Access Compliance Report

Public Rights-of-Way

(Curb Ramps)

Intersection ID: 44464	Main Street: BAYVIEW_PY	Cross Street: VALCOURT_RD	Location: NE
ADA ID: 56D8B4C4B850	Ramp Type: PerpDiag	Initial Pass/Fail: Fail	Overall Compliance: No
Severity Score: 17.5			
Codes/Mitigation Info/Possible Solution		Field Measurements/Component Compliance

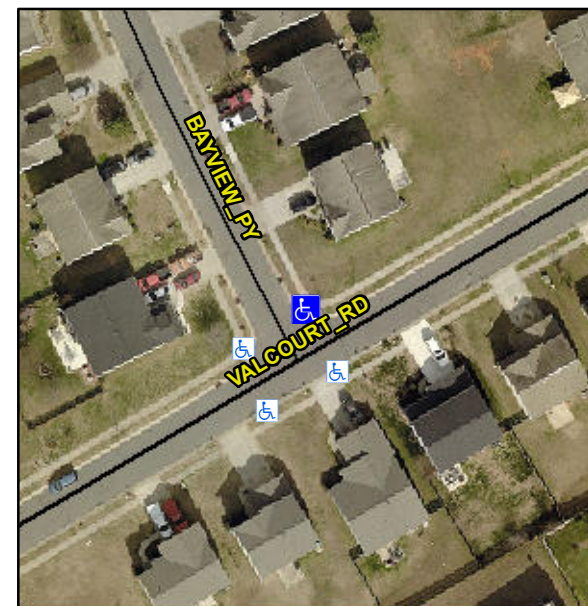
Not Found, R304.5.1

Compliance	Description	Data	Compliance	Description	Data
N/A	Ramp Length (in)	49.0	Yes	Ramp Slope (%)	5.7
No	Ramp Width (in)	33.5	Yes	Ramp XSlope (%)	1.2
N/A	Flare Type LT	N/A	N/A	Flare Type RT	N/A
N/A	Flare Slope LT (%)	N/A	N/A	Flare Slope RT (%)	N/A
N/A	Flare Traversable LT?	N/A	N/A	Flare Traversable RT?	N/A
N/A	Landing Length (in)	N/A	N/A	DWS Provided?	N/A
N/A	Landing Width (in)	N/A	N/A	DWS Contrast?	N/A
N/A	Landing Slope (%)	N/A	N/A	DWS Length (in)	N/A
N/A	Landing X Slope (%)	N/A	N/A	DWS Full Width?	N/A
N/A	Landing Curb? (Y/N)	N/A	N/A	DWS Offset (in)	N/A
N/A	Shared Landing?	N/A			
N/A	Gutter Ponding?	N/A	N/A	Gutter Slope (%)	N/A
N/A	Gutter Lip Ht (in)	N/A	N/A	Gutter X Slope (%)	N/A
N/A	Painted X Walk1?	No	N/A	Painted X Walk2?	No
	X Walk 1 Direction	To W		X Walk 2 Direction	To S
N/A	X Walk 1 Width (in)	N/A	N/A	X Walk 2 Width (in)	N/A
	X Walk 1 Slope (%)	4.2		X Walk 2 Slope (%)	2.7
	X Walk 1 X Slope (%)	1.1		X Walk 2 X Slope (%)	3.3

Remove & Replace Curb Ramp With Two New Directional Ramps or Equivalent.
